Zoning Challenge and Appeal Form

Every area measurement in the drawing is demonstratively wrong or highly suspect. Consequently, the building is out of FAR compliance with ZR 111-20

RE: Zoning Challenge
65 West Broadway
Block 133, Lot 15
Job No: 121190497

Detail of ZD1 plan view

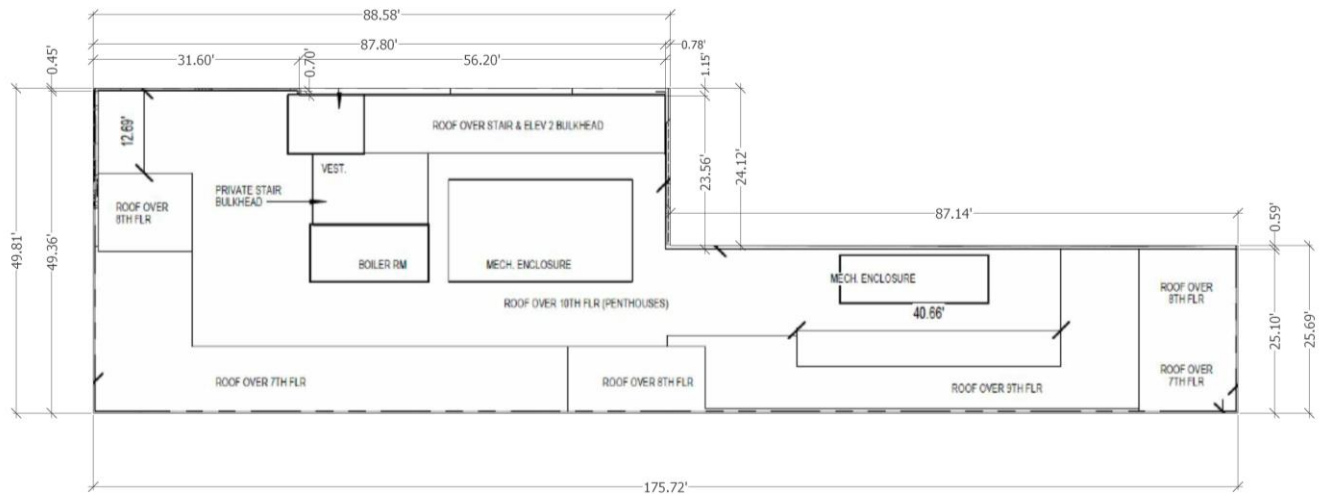
We started by checking the gross floor area of the ground floor. The following is the detail of the plan found in the ZD1.

Detail of ZD1, overlain with rectangles to demonstrate the actual GSF of this floor

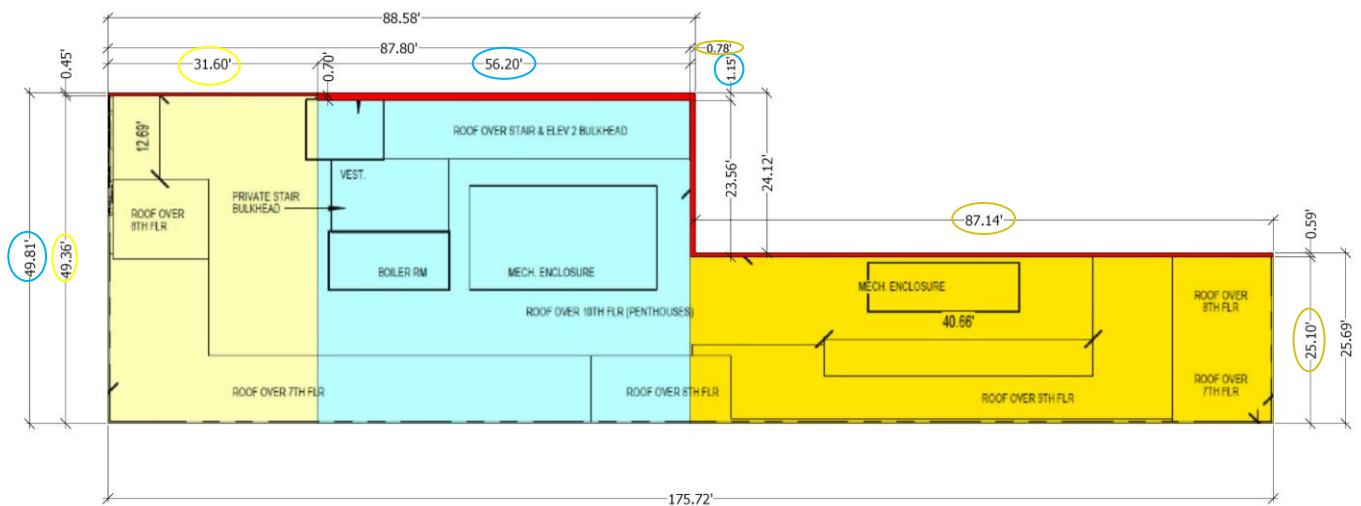
My office then segmented the plan into rectangles where the area can be easily calculated using simple geometry (e.g. length * width) rather than CAD. The yellow, blue and mustard areas are rectangles covering the entire ground floor of the building. The thin red area is open and not counted in gross building floor area.

$$\text{Yellow} = 49.36 \times 31.6 = 1,559.78$$

$$\text{Blue} = (49.81 - 1.15) \times 56.2 = 2,734.69$$

$$\text{Mustard} = 25.1 \times (87.14 + 0.78) = 2,206.79$$

$$\text{Gross Floor Area ground floor} = 6,501.26$$

$$\text{Gross Floor Area claimed in ZD1} = 6,281.00$$

Amount ground floor understated = 220.26 GSF

Please note that this arithmetic is using the dimensions shown on the applicant's drawing (and circled in drawing), and can be done by anyone without computer tools; the 220 GFA understatement of the ground floor is in plain sight. A similar discrepancy is seen on almost every floor,¹ resulting in a building that is about 1,600 GSF larger on floors 1 through 10 than what is shown in the ZD1 table. Considering that ZFA is calculated by deducting exempt areas from the GSF number, this is a significant and material error and will require a new drawing.

Detail of sheet 10, showing the 4th Floor QH deductions

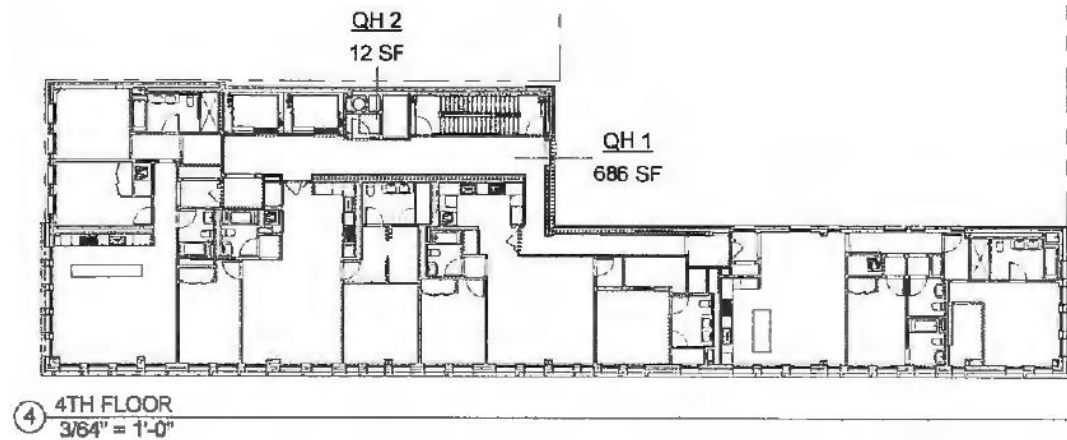
This 4th floor hallway shows the hallway, labeled QH1 686 SF, as a quality housing deduction. It has a window and so qualifies for the deduction for a day-lit hallway. In addition, because of the number of apartments on the floor, it also qualifies for the density deduction. Both of these deductions are 50%, and when taken together, means that the entire hallway will be removed from zoning floor area. My office has measured the hallway below in CAD:

Detail of sheet 10, delineating the hallway from wall-to-wall. My office shows it as 543 SF.

The blue shaded area shows the area of the hallway according to our delineation, and the area is calculated at 543 SF when the area of the hallway is measured wall-to-wall. The applicant, however, is showing this hallway at 686 SF, which is 143 SF larger than it actually is. How did this happen? It all depends on where the line for the hallway is drawn. When calculating gross floor area, measurements are taken to the very edge of the exterior wall. However, when calculating deductions for things like hallways, shafts, and chases, the measurements must be made wall-to-wall, excluding the wall thicknesses. If we redo the hallway measurement done above to include all abutting wall thicknesses, as shown in the drawing below, we get a different result:

Detail of sheet 10, delineating the hallway from including all walls: the area nearly exactly matches the deduction claimed.

Detail of sheet 9, showing M-3 in blue. The left is measured to produce the applicant's deduction. The right shows M-3 as it should have been measured.

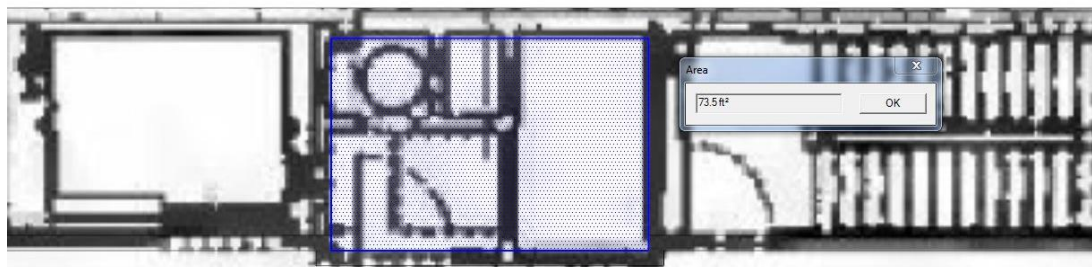
To be clear, this is not the correct way to measure this deduction, but it does produce nearly the result the applicant is claiming. The quality housing deductions claimed for the hallways are substantially overstated. Unfortunately, this measurement error for the deductions are not only limited to the quality housing deductions. The mechanical deductions also suffer from serious overstatement. For example, consider area M-3, which appears to be a small chase and is detailed on sheet 9 of the aforementioned Z-series plans. The chase is outlined in blue below using two different methods.

On the left, we have measured the chase using all the exterior walls. This equals the 14 SF deduction claimed for it. On the right, the chase is measured as it should have been measured, which shows it as less than half the size: 6 SF.
